Poplar Street Bridge

Independent Review

Conducted for East-West Gateway Council of Governments

September 12, 2012

Option 1: Ramp B under I-64 (right exit), inside merge

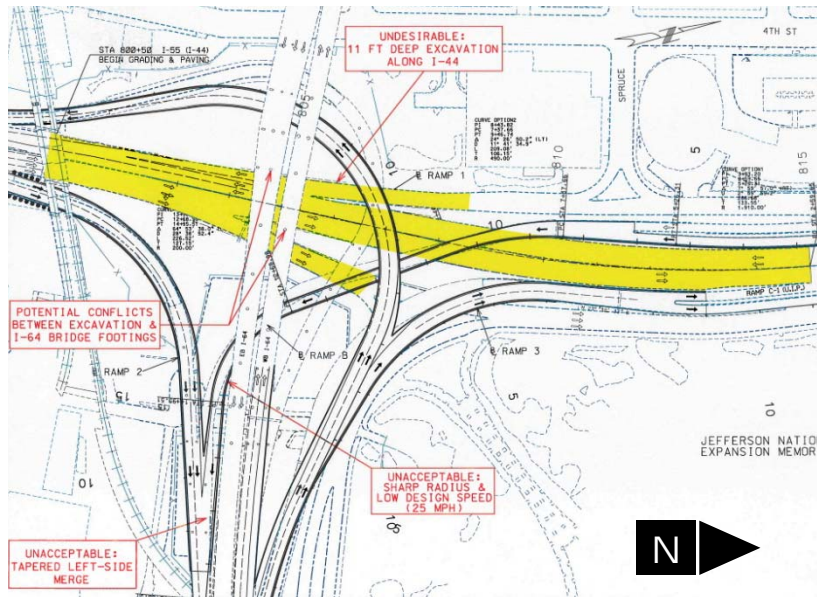
Option 1 generally attempts to preserve Ramp B on its existing alignment, joining Ramp A from the left side. With Option 1, the grade of I-44 through the interchange would need to be lowered significantly in order to provide necessary vertical clearances to accommodate both Ramp B and a widened, realigned Ramp D (westbound-to-southbound) under the I-64 mainline. Excavation for this lowering would potentially conflict with the I-64 bridge piers. In addition, the Ramp B curvature would provide an undesirable design speed of 30 mph and the left-side taper would be unacceptably short (due to proximity to the PSB abutment). The study team generally agreed with MoDOT’s assessment, and could not identify modifications to improve the concept.

Option 2: Ramp B under I-64 (left exit), outside merge; I-44 realign

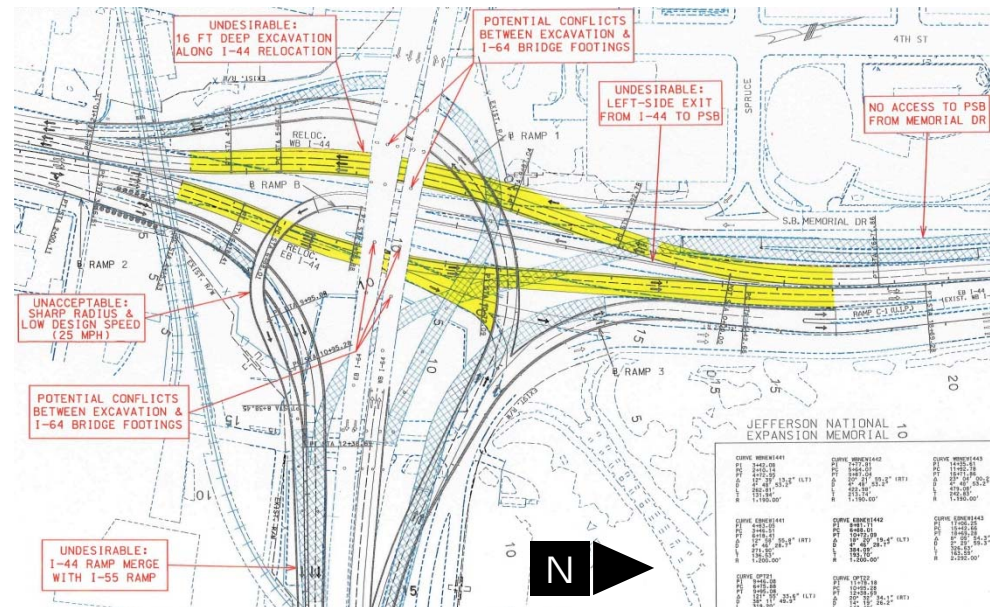
Option 2 would bend I-44 out to allow provision of a left-exit for Ramp B, which would still travel under Ramp D and the I-64 mainline, but would rise above Ramp A to join it from the right side. As with Option 1, the grade of I-44 through the interchange would need to be lowered significantly in order to provide necessary vertical clearances to accommodate the ramp changes. The excavation for this lowering would conflict with the I-64 bridge piers. In addition, the Ramp B curvature would provide an undesirable design speed of 30 mph and the merge with Ramp A would be undesirable. Also, this option would cut off access to PSB from Memorial Drive. The study team generally agreed with MoDOT’s assessment and could not identify modifications to improve the concept.

Option 3: Ramp B over I-64 (right exit), outside merge

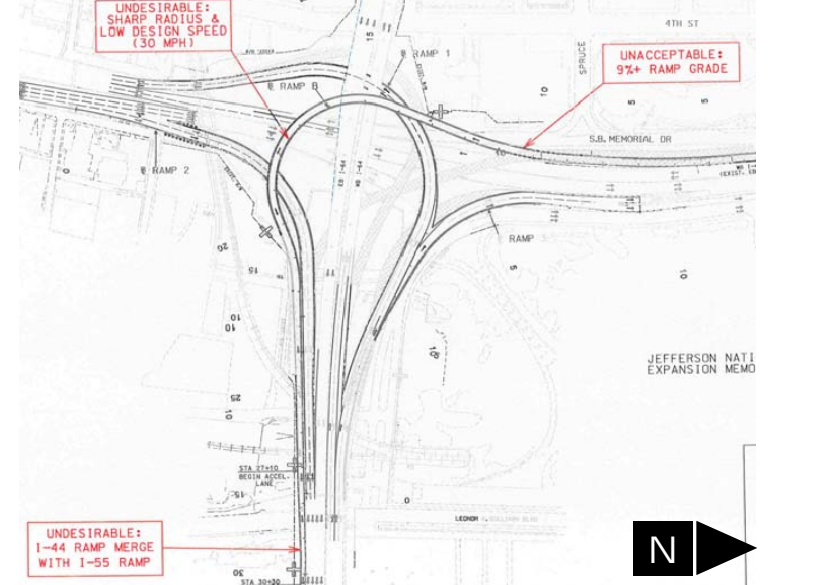
Option 3 would elevate Ramp B to the highest vertical level at the interchange, above I-64 mainline and Ramp A. Ramp B would merge with Ramp A from the right. The problems of undesirable ramp curvature and an undesirable merge would remain with this alternative and MoDOT indicated that Ramp B would provide an unacceptable grade. The study team generally agreed with MoDOT’s

assessment, although it was felt that the ramp grade could be reduced with one of two techniques identified in **Table 2-2**.

Issue		Response	Mitigation possible?	Standard	Ref
Option 3: Ramp B over I-64 (right exit), outside merge					
UA	7.1% ramp grade	Agree. Caused by req'd 14'6" clearance over WB I-64 + 6' structure depth	(1) Move VPI to Sta 15+00, EL 512.90; results in 6.7% grade in, 4.61% grade out; hold K=20, L=230' (2) Reduce structure depth so grade can be reduced	7% max, 25-30 mph	AASHTO Sec 10.9.6
UD	Sharp radius & low design speed (30 mph)	R=235'	Increasing to R=340' (35 mph) is not possible because curve would overlap upstream curve.	30 mph Design Speed: R=231' (6% super)	AASHTO Table 3-9
UD	I-44 ramp merge with I-55 ramp	Agree. It is undesirable to merge a ramp into a directional interchange ramp movement.	None. Merge would have to occur on main span of PSB structure to avoid this situation	N/A	N/A
Option 5: Ramp B under I-64 (right exit), outside merge; Memorial realign					
UA	Sharp radius & low design speed (25 mph) - SB-to-EB	Agree. R=152.50'	Increasing radius to 231 ft (30 mph) would not fit between piers and would substantially increase skew angle over Ramp 2	30 mph Design Speed: R=231' (6% super)	AASHTO Table 3-9

Option 5: Ramp B under I-64 (right exit), outside merge; Memorial realign

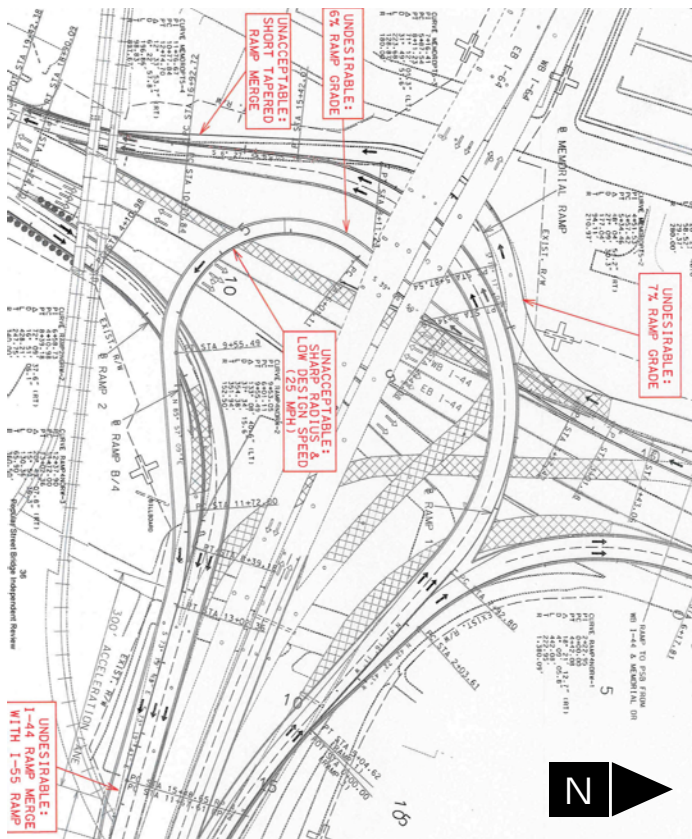
Option 5 bears many similarities to Option 2, except instead of realigning I-44, it would curve the Memorial Drive Ramp westward to allow development of a right-exit for Ramp B. Ramp B would travel under Ramp D and I-64 mainline, but over I-44 mainline and Ramp A. The problems of undesirable ramp curvature and an undesirable merge would remain with this alternative, and MoDOT indicated that Ramp B and the realigned Memorial Drive Ramp would provide unacceptable grades. The study team generally agreed with MoDOT’s assessment, although it was felt that the Ramp B grade could be possibly reduced with one of two techniques identified in **Table 2-2**.

7th Street U-Turn

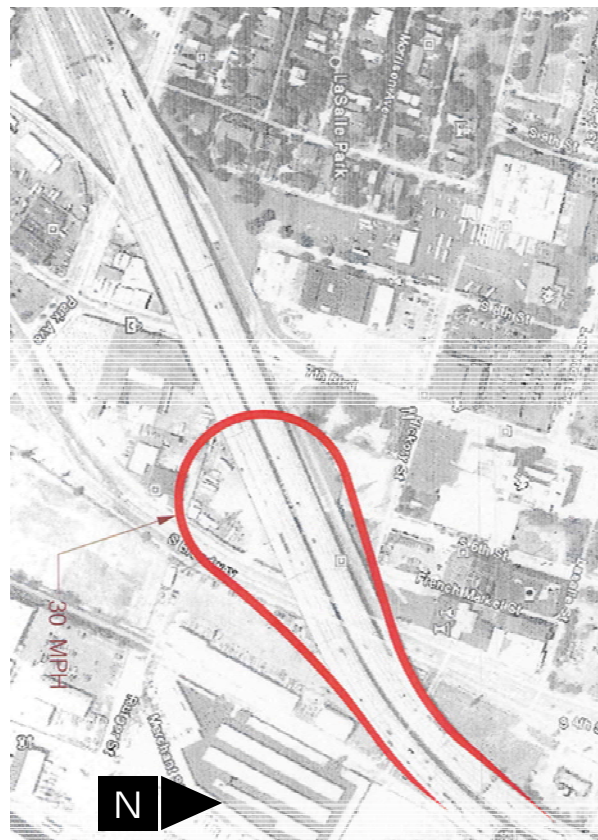
This option would eliminate Ramp B and move the southbound-to-eastbound movement about a half-mile south of the interchange, creating a U-turn ramp in the vicinity of Seventh Street. MoDOT’s primary stated concern with this option was the design speed of the ramp, which would be difficult to increase. The study team agreed with this assessment. In addition, it would be desirable to avoid the out-of-direction travel required by this option, if possible.

Alternative 2A: Ramp B under I-64 (right exit), outside merge; I-44 slight realign; Memorial realign

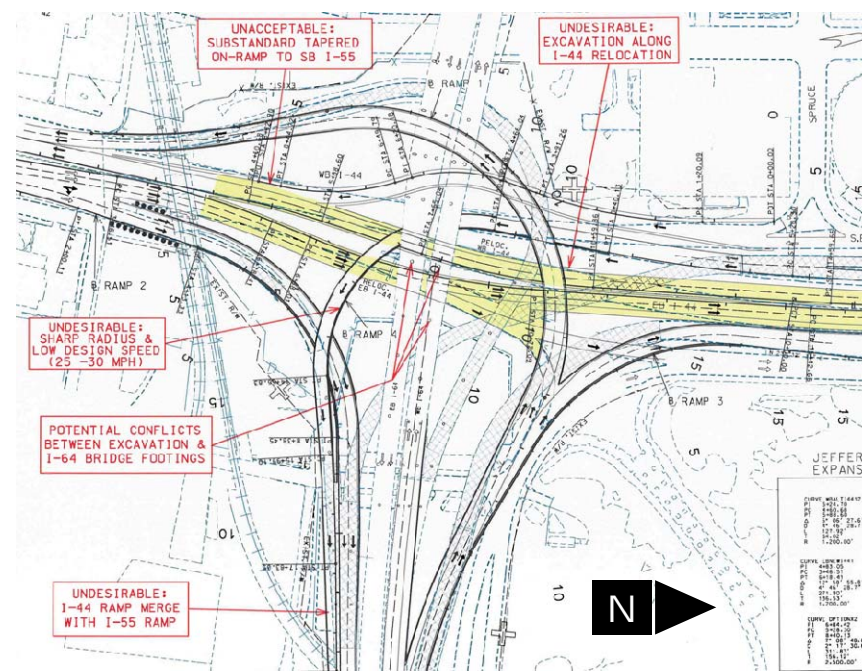
Alternative 2A is essentially a combination of Options 2 and 5, slightly realigning both I-44 mainline and the Memorial Drive ramp to allow a right-exit from southbound I-44 onto southbound Memorial Drive, and a subsequent left-exit to a realigned Ramp B, which would merge with Ramp A from the right. The problems of undesirable ramp curvature and an undesirable merge would remain with this alternative, along with undesirable excavation along I-44 (including potential conflicts with I-64 bridge footings). In addition, the Memorial Drive on-ramp to I-55 would exhibit a substandard taper. The study team generally agreed with MoDOT’s assessment and could not identify modifications to improve the concept.

Alternative 2A: Ramp B under I-64 (right exit), outside merge; I-44 slight realign; Memorial realign					
UA	Substandard tapered on-ramp to SB I-55	Agree. L=250'	Longer taper would interfere with Ramp 1 merge downstream.	800' (50:1)	AASHTO Fig 10-69
UD	Excavation along I-44 relocation - SB	Agree. Caused by bringing I-44 vert curve under TRRA bridge to current standards for 50 mph design speed	Design sag curve for comfort criteria, AASHTO eq 3-51; reduces excavation depth, still undesirable	K=96; 50mph sag	AASHTO Table 3-36
UD	Sharp radius & low design speed (30 mph) - SB-to-EB	R=235'	Increasing to R=340' (35 mph) is not possible because curve would overlap upstream curve.	30 mph Design Speed: R=231' (6% super)	AASHTO Table 3-9
UD	I-44 ramp merge with I-55 ramp	Agree. It is undesirable to merge a ramp into a directional interchange ramp movement.	None. Merge would have to occur on main span of PSB structure to avoid this situation	N/A	N/A

Potential conflicts between excavation & I-64 bridge footings (SB thru)	Agree. Excavations are unacceptably close to I-64 pier foundations.	None with this option. Substantial I-44 excavation is required for Ramp 4 to pass under I-64 and over I-44 at the location shown.	N/A	N/A
